**LEGAL ADVERTISEMENT
HISTORIC PRESERVATION BOARD
CITY OF PORTLAND
Public comments are taken at all meetings.**

CITY OF PORTLAND, MAINE
HISTORIC PRESERVATION BOARD

**WORKSHOP
100 COMMERCIAL STREET (THOMAS BLOCK)**

**PUBLIC HEARING
392 SPRING STREET**

3. Flip vehicular entry

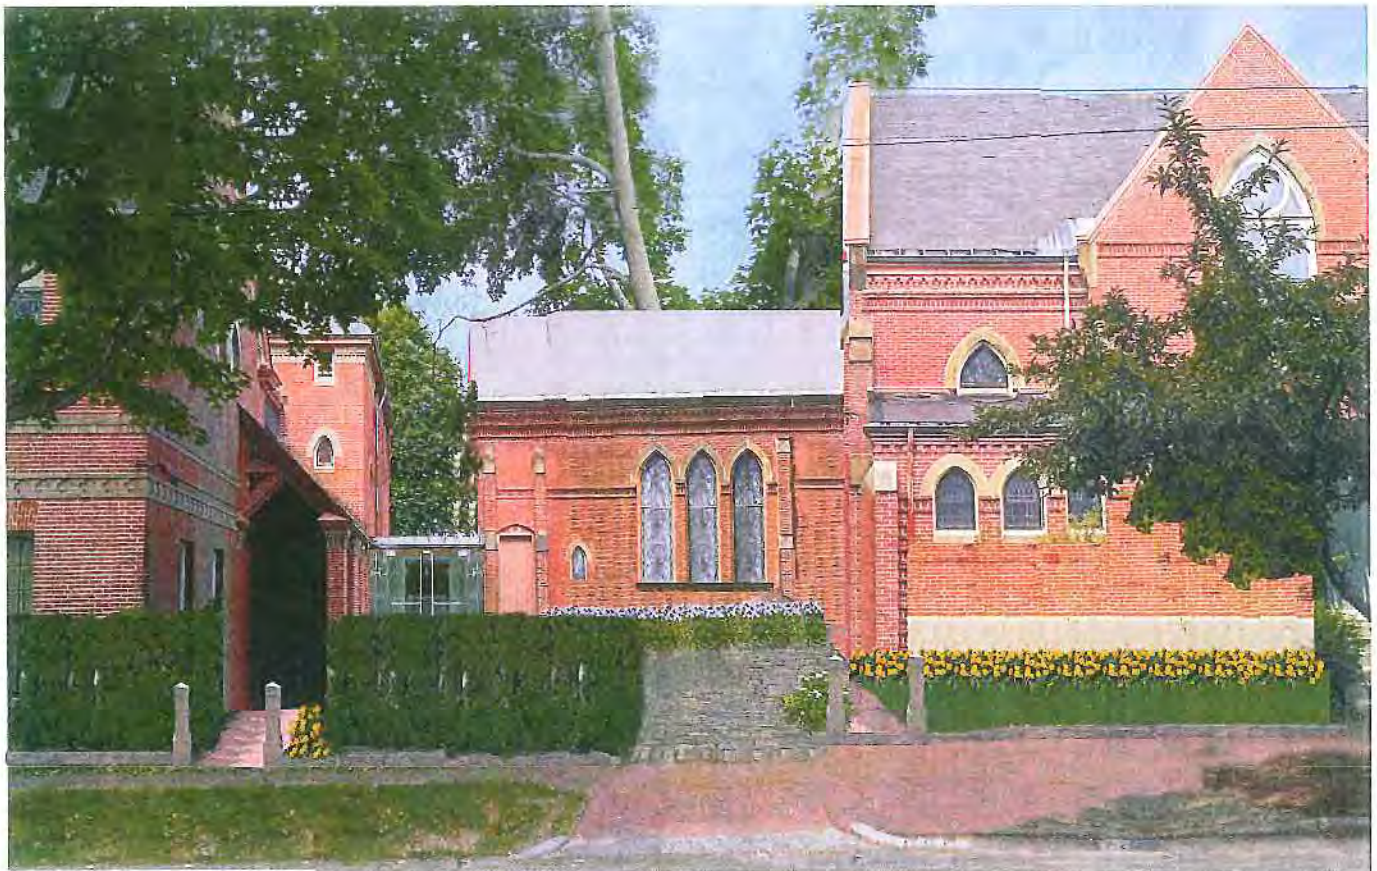
c. The HPC expressed discomfort with the drive entry located on the center line of the three dominant stained glass windows on the East facade. Surrounded by such magnificent architecture, site design moves should be deliberate. Given the logic of 3a., locating the drive slightly off-center of the three windows might appear jarring or look like "a mistake". In order to mitigate any "hardness" or "abruptness" in the meeting of the drive and the Church wall, this revised plan places increased plantings at the base of these windows, between the drive and the wall. The view from Thomas Street will be formed by the ground plane of pavers, softened by plantings and framed by the adjacent building elevations - recalling the simplicity of the 1931 photograph.

Conclusion: In order to restore the historic simplicity of site design, the drive entrance will remain on the Church side of the courtyard and the cars will park in front of the Parish House side of the courtyard, as shown in the mock-up photograph below:
